Access Compliance Report Public Rights-of-Way (Pedestrian Signals)

Main Street: **S_BROOKHURST_ST** Cross Street: **BALL_RD** Location: **SE**

ADA ID: **SGAT220202153421** Signal Type: **One Push Button-Non APS** Overall Compliance: **No** Severity Scores: **BTN 1: 10 BTN 2: N/A No BTN: N/A**

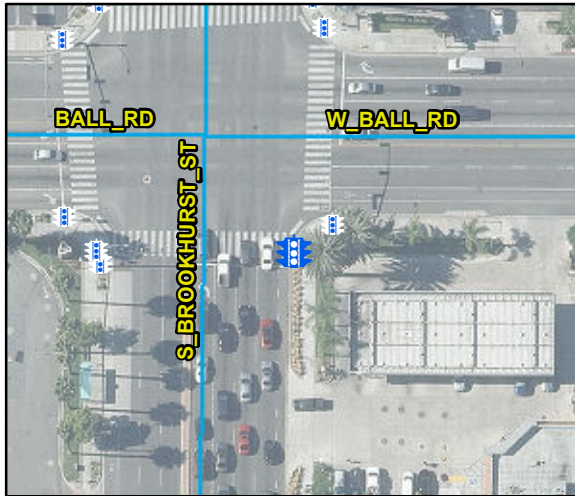
OC Std/PROW: MUTCD 4e.08

Possible Solutions: Replace Signal Push Button With APS Button.
